Citizens Working Group Recommendations to the Joint Cities Working Team on the Stevens Creek Trail Feasibility Study

STEVENS CREEK TRAIL FEASIBILITY STUDY
CITIZENS WORKING GROUP PREFERRED ALIGNMENT

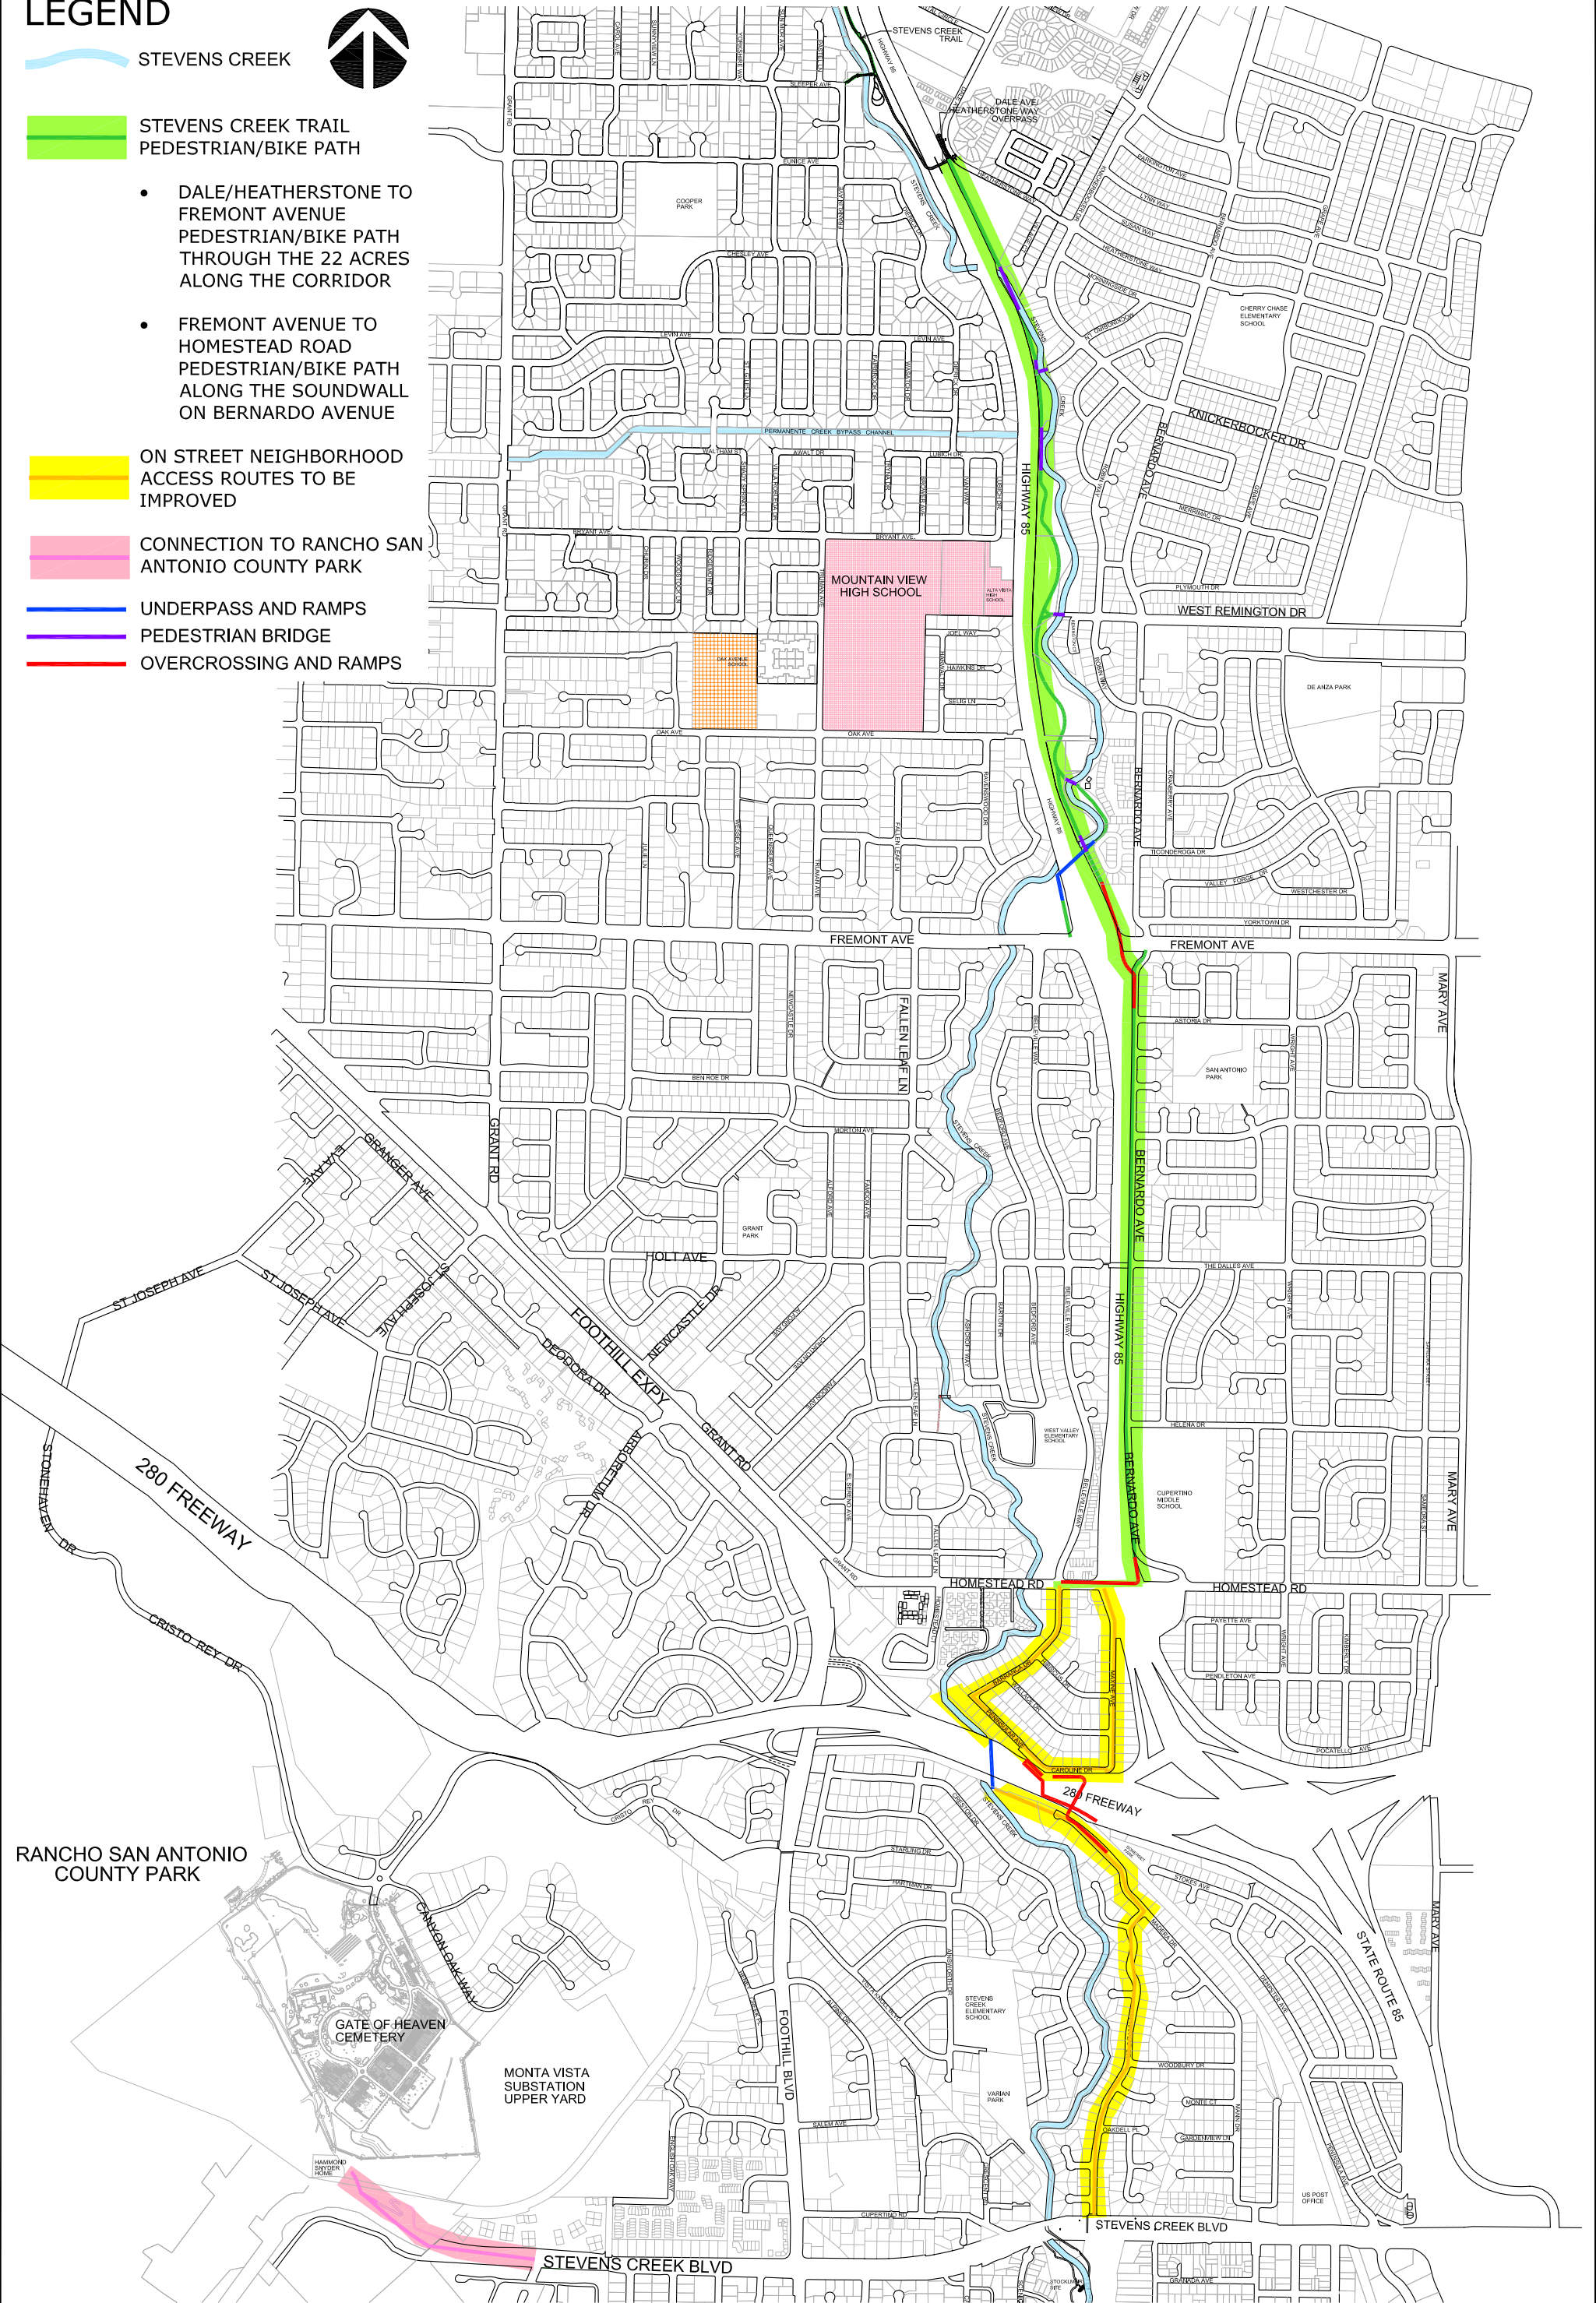
- The preferred alignment and top priority is to extend the Stevens Creek Trail through the 22 acres of open space along State Route 85 from Dale/Heatherstone to Fremont Avenue. The trail should incorporate habitat enhancements and the 22 acres along the creek corridor should be managed as passive open space.
- Develop the project in phases, as needed, to construct as soon as possible. Suggested phases include Dale/Heatherstone to Remington and Remington to Fremont Avenue.
- Include a neighborhood access point at Remington Avenue.
- Continue to explore the potential for an overcrossing over Highway 85 to provide a connection to Mountain View High School, which would provide

- The preferred crossing of Fremont Avenue is a pedestrian/bike overcrossing to Bernardo Avenue to continue the separated pedestrian/bike path.
- A second connection to Fremont Avenue is also recommended via a trail underpass beneath State Route 85 connecting to Fremont Avenue west of the Highway 85 interchange adjacent to the southbound off-ramp. A preferred alternative to make this connection is to pursue a trail easement along the creek through the parking lot located at 1195 W. Fremont Avenue (current Stanford medical office).
- When the Fremont Avenue bridge over Stevens Creek is replaced in the future, consider a trail underpass to facilitate pedestrian and bicycle crossings of Fremont Avenue and provide an access point to the trail.

- If a pedestrian overcrossing at Fremont Avenue is considered feasible, the preferred alignment to extend the Stevens Creek Trail is a separated off-street pedestrian/bike path along the soundwall on Bernardo Avenue. This pedestrian/bike path would continue the experience of the trail by providing a route free from automobile traffic.

- The feasibility study indicates that a road reconfiguration of Bernardo is necessary to support the off-street pedestrian/bike path. Conduct traffic and parking studies to determine the feasibility of either one-way traffic or two-way traffic with loss of parking.

- If a separated pedestrian/bike path were not feasible on Bernardo, the second choice would be to modestly enhance Bernardo, Belleville and Fallen Leaf streets with bicycle safety improvements and wayfinding signage to the trail. None of these on-street routes would be designated as the Stevens Creek Trail. Even if the off-street route on Bernardo is considered feasible, evaluate bicycle safety improvements that could be made with modest improvements to Belleville and Fallen Leaf.

- Connect the pedestrian/bike path on Bernardo to the pedestrian/bike path on the north side of Homestead Road in Los Altos. The Homestead Road path currently extends from Stevens Creek west to El Sereno Avenue near the Grant Road/Foothill Expressway intersection. Continue to explore either a) widening the existing Homestead Road Bridge over State Route 85 or b) placing a new pedestrian/bike bridge parallel and just to the north of the Homestead Road bridge and making path improvements in Sunnyvale west from State Route 85 interchange to Stevens Creek to provide for a continuous off-street path. Extension of the Homestead Road path could proceed as a

- i. The preferred crossing is a trail underpass beneath Interstate 280 using one of the existing tunnels that convey the Stevens Creek flows to San Francisco Bay. This option is potentially technically feasible but was previously not supported by Caltrans. The use of one of the tunnels should continue to be pursued as a long-term solution to extending the trail south. The tunnel route would connect Barranca Drive to Madera Drive. The trail would use Madera Drive to Phar Lap Drive to access Stevens Creek Blvd., where it would connect to the existing trail in Cupertino.

- ii. An alternate choice is a pedestrian overcrossing that spans both Interstate 280 and the UPRR tracks connecting Peninsular Avenue to Madera Drive.

- iii. Another option to consider if the previous two alternatives for crossing I-280 were considered infeasible is a pedestrian overcrossing that spans only Interstate 280 connecting Caroline Drive to Somerset Square Park located off Stokes Avenue.

- A pedestrian/bike path that extends along the north side of Stevens Creek Boulevard west from Stonebridge to undeveloped open space land behind the Gate of Heaven Cemetery is recommended to provide access to Rancho San Antonio County Park. This alignment would include a pedestrian/bike bridge over the UPRR tracks to provide a connection to the Hammond-Snyder Loop Trail in Rancho San Antonio County Park. This route is viewed as an important recreational amenity for the community and could be developed as a stand-alone project.
- A trail staging area with parking, restrooms and signage is recommended. The additional parking area would provide a more convenient access into Rancho San Antonio County Park and would also help reduce parking demand at the busy Rancho San Antonio parking lots.
